Part Number Update

Bulletin No: PNU-206

Subject: **Bendix Announces New Part Numbers for Bendix® TABS-6™ Standard Controller for Tank- or Frame-mounted Units**

**Bendix® TABS-6™ Standard Controller
(shown without connector cover installed)**

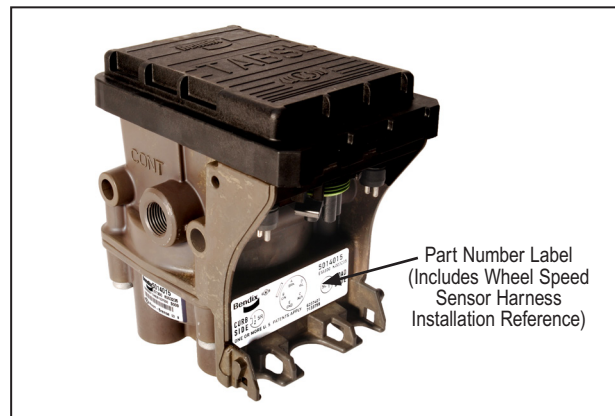
Trailer System	Old OE Part Number	Old AM Part Number	Crack-Pressure	New OE Part Number	Order New AM Part Number	New Controller Crack-Pressure
Two (2) Sensors, One (1) Modulator (2S/1M) Axle Systems Only	5014015	801855	3.0±0.5 psi	K109807	K109808	4.5±0.5 psi For improved brake balance performance. Additionally, Bendix® brand air disc brake applications no longer require a 3.3 psi crack-pressure quick-release valve.
Two (2) Sensors, One (1) Modulator (2S/1M) Dolly Axle Systems Only	5014112	801990	3.0±0.5 psi	K109809	K109812
